COMMUNITY DEVELOPMENT DEPARTMENT REPORT

APPLICANT: Brighton Corporation

SUBJECT: H-2025-0051; A-2025-0152
Driftwood Townhomes Subdivision

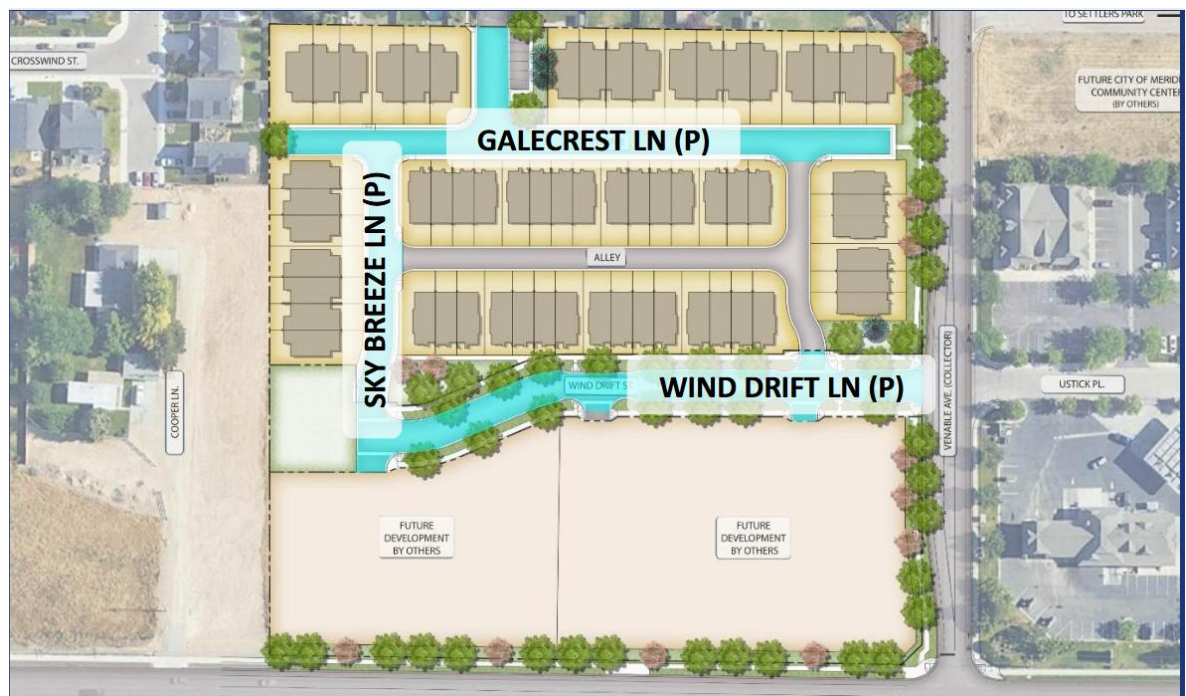
A 5' wide detached sidewalk is required within the street buffer along N. Venable Ave., a collector street, and a 5' wide attached sidewalk or 4' wide detached sidewalk is required along the proposed private streets. A 5' wide detached sidewalk exists along both sides of the proposed private street adjacent to the southern boundary of the development.

The Applicant requests Director approval of a modification to the requirement along private streets on Lot 1, Block 1 to allow a 4' instead of 5' wide attached sidewalk. Such modifications are allowed if the Applicant can demonstrate that an alternative similar pedestrian path exists. The Director finds the proposed sidewalk provides a similar pedestrian path as required for a modification; therefore, the modification is approved.

Staff recommends an attached 4' wide sidewalk is provided along the west side of Alley A for safe pedestrian access within the development in accord with UDC 11-3F-4A.2.

- iv. Depict an attached 4' wide sidewalk along the west side of Alley A for safe pedestrian access within the development in accord with UDC 11-3F-4A.2.

- ii. Depict the location of the dog waste station.
 - iii. Depict an attached 4' wide sidewalk along the west side of Alley A for safe pedestrian access within the development in accord with UDC 11-3F-4A.2.

I. Pedestrian Plan

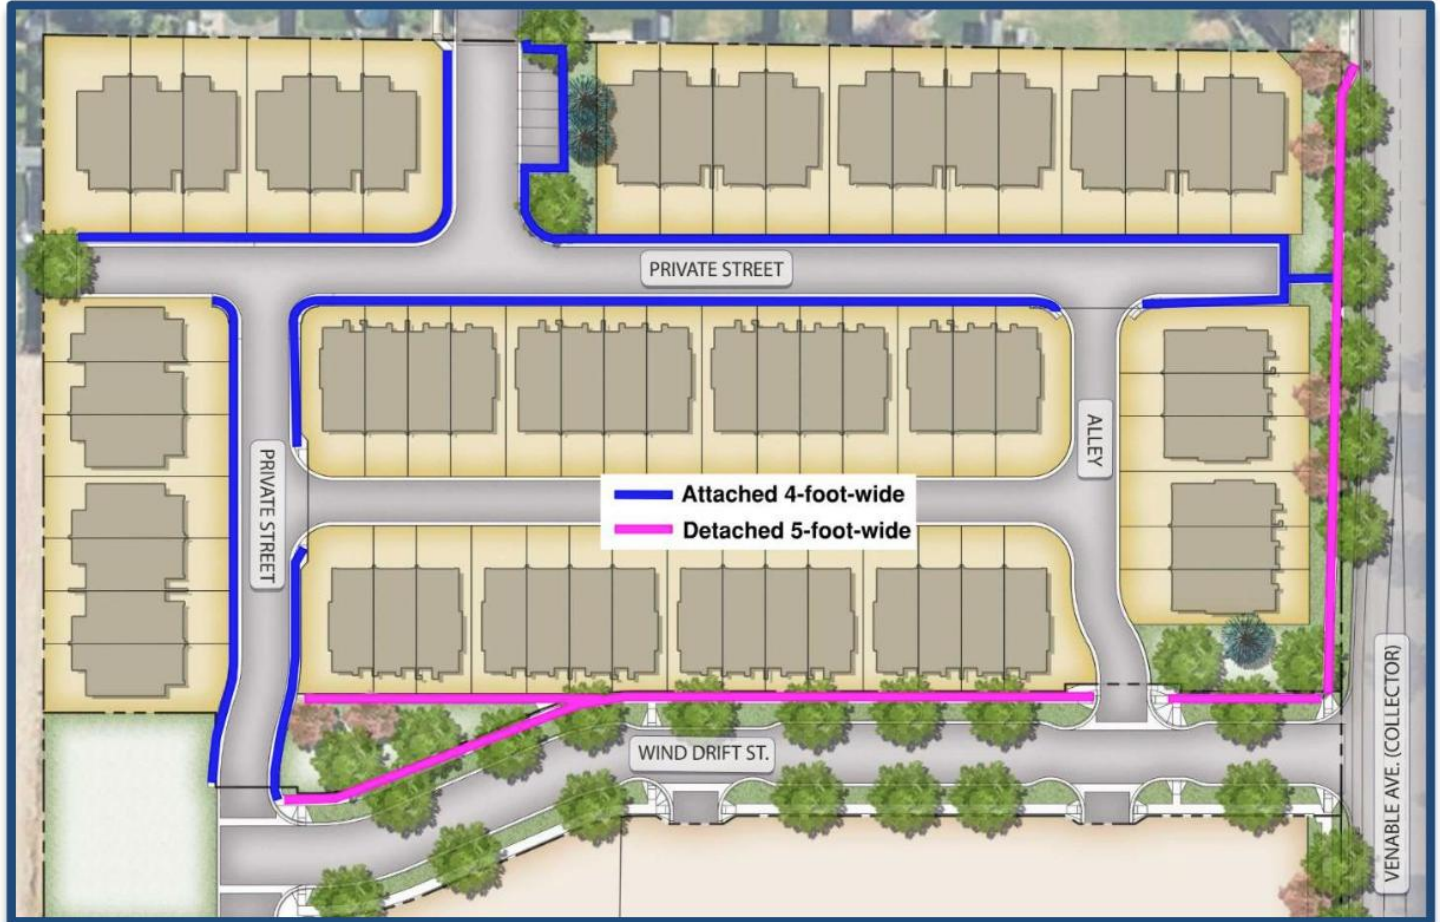
A pedestrian plan was submitted that shows internal pedestrian pathways and sidewalks along streets, included below in Section VII.I.
